TK Elevator EOX

The following shows some examples of what should be done & how to prove that the work was performed.

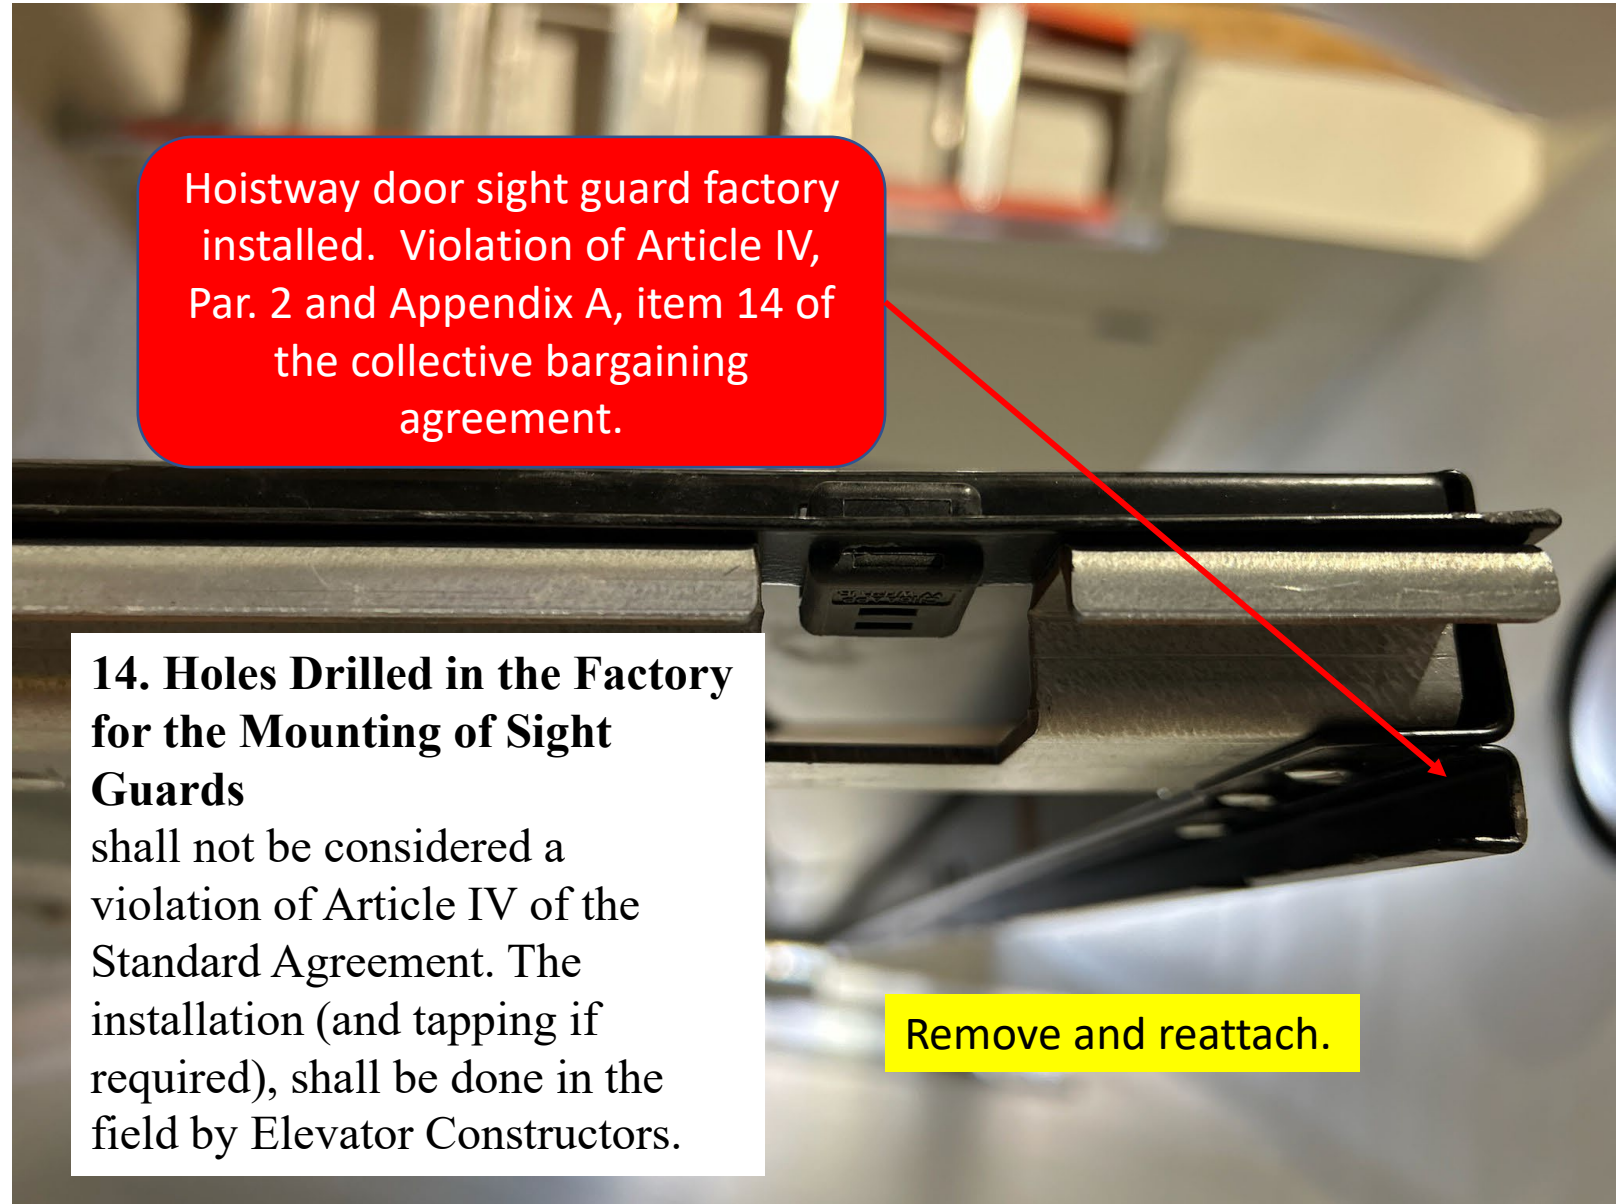
Hoistway door locking device factory installed. Violation of Article IV, Par. 2 (n) of the collective bargaining agreement.

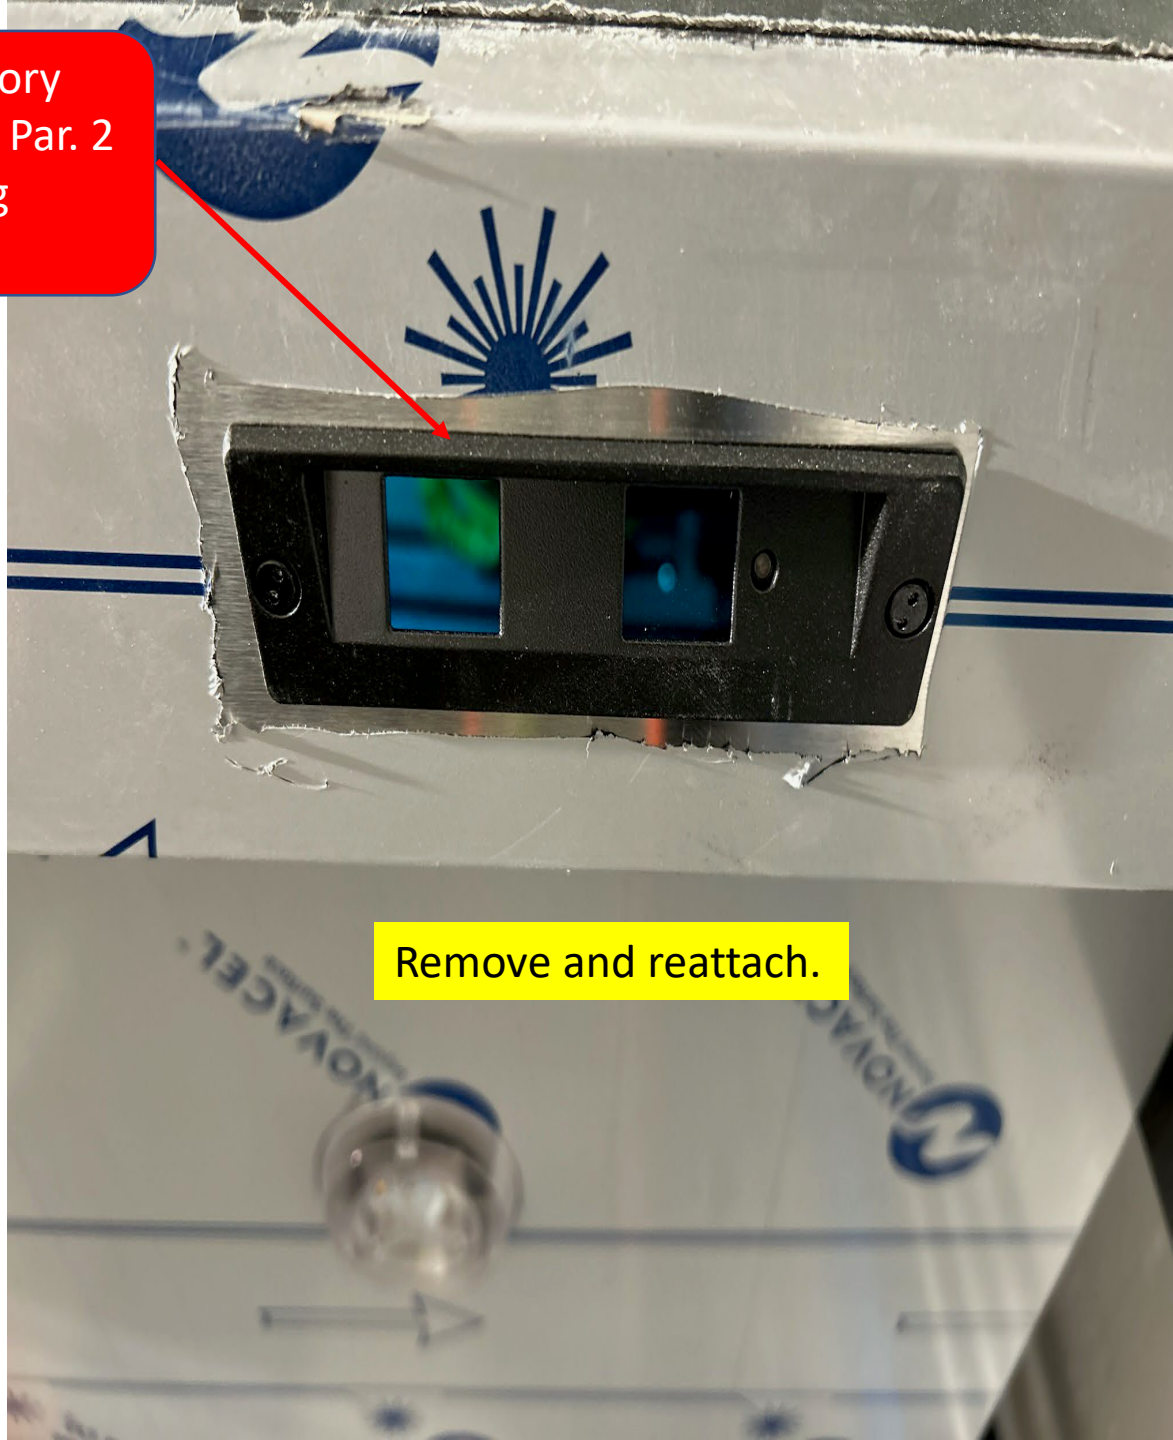
Car camera factory installed in canopy.
Violation of Article IV, Par. 3 (11) of the
collective bargaining agreement.

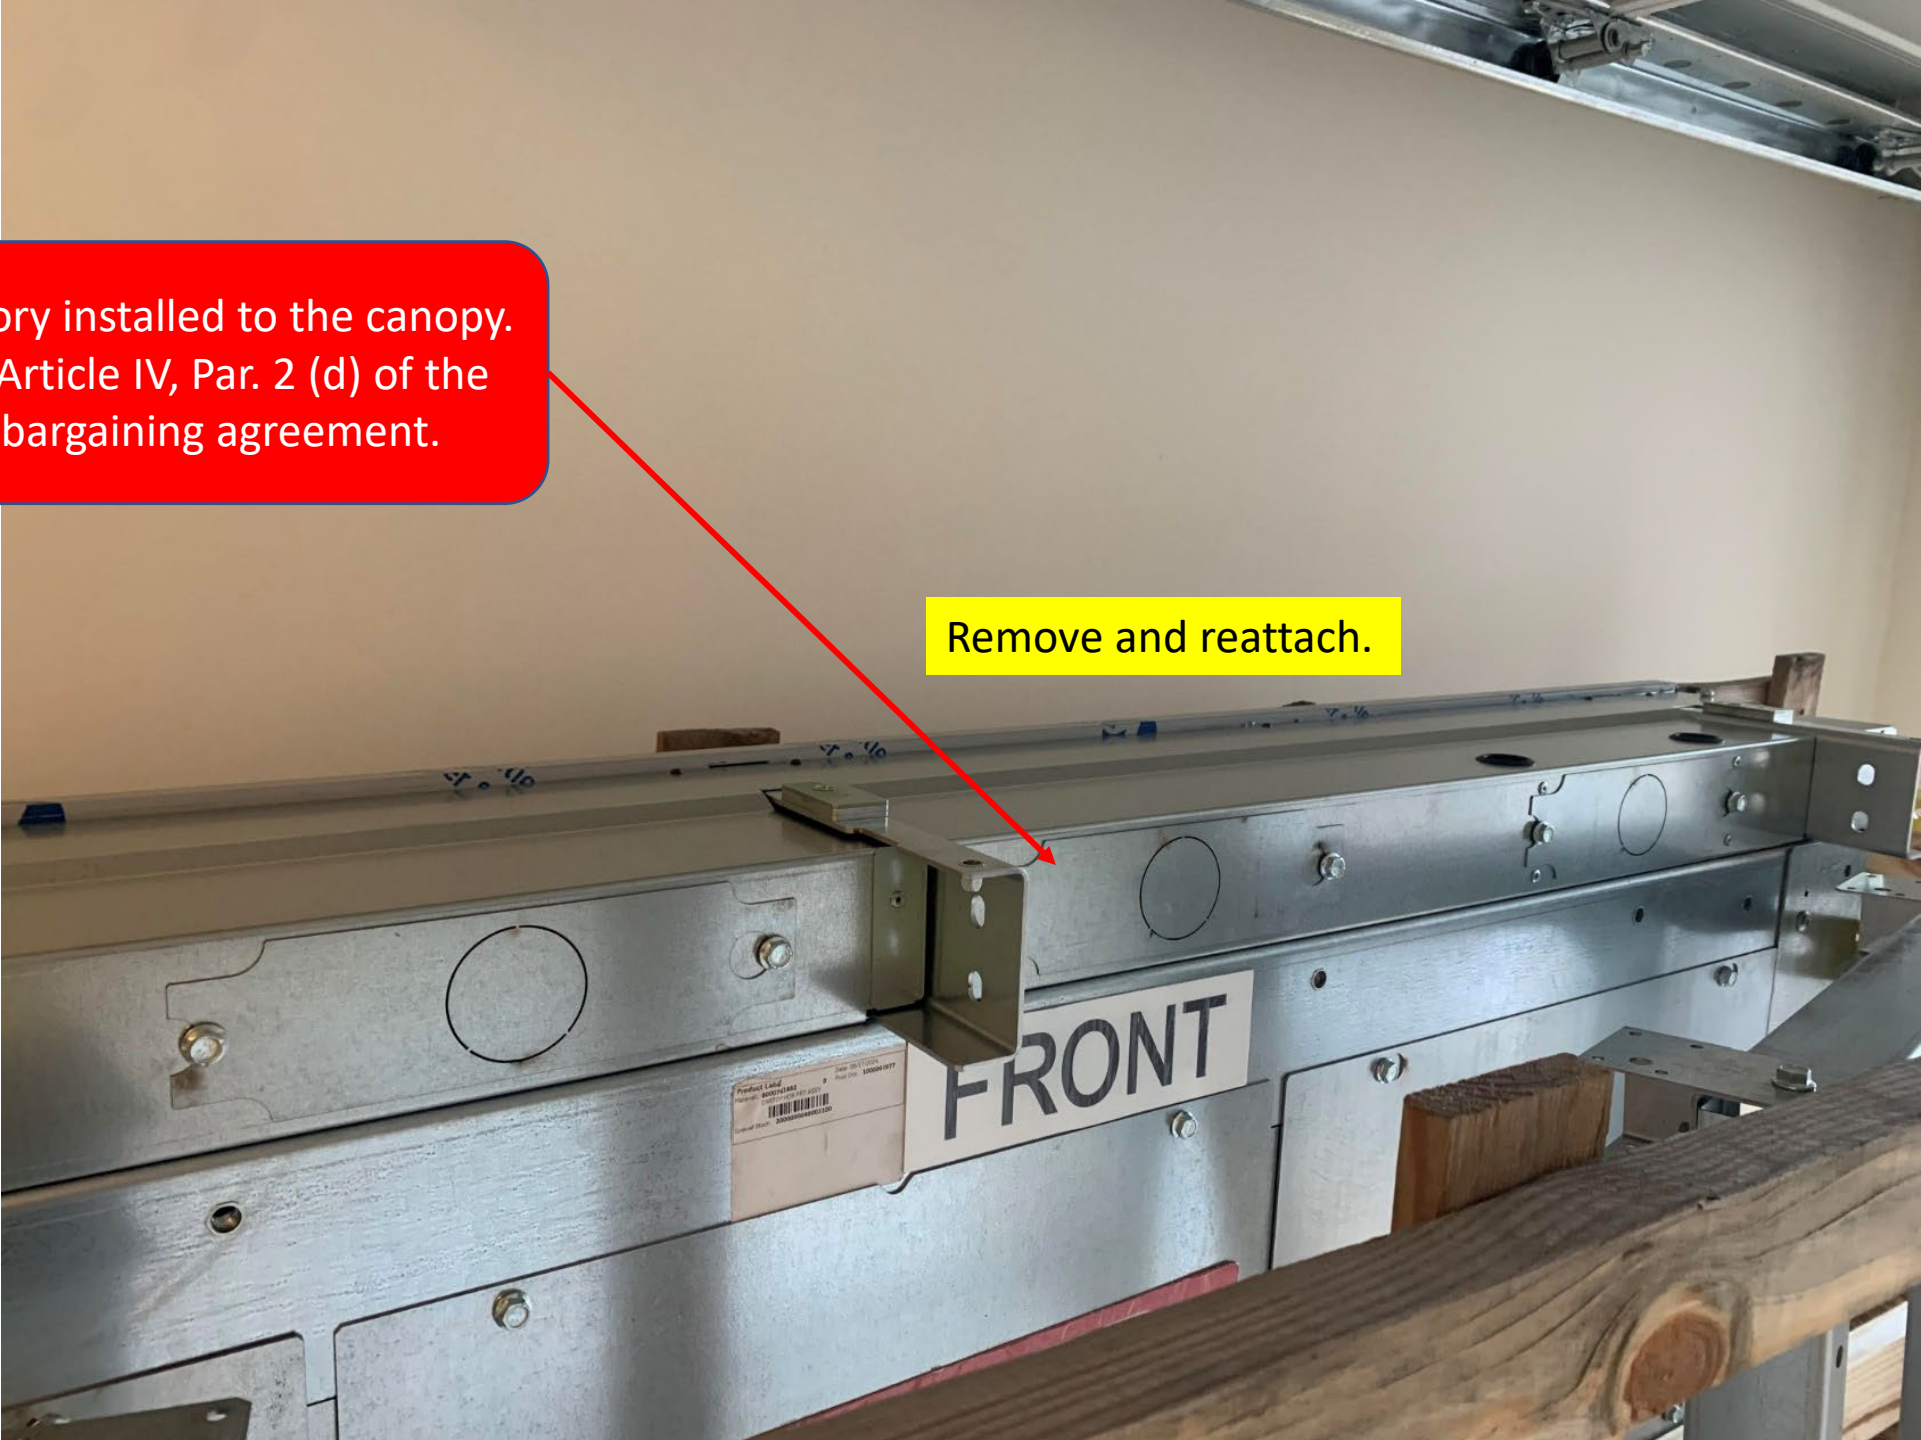
Raceway factory installed to the canopy.
Violation of Article IV, Par. 2 (d) of the
collective bargaining agreement.

Remove and reattach.
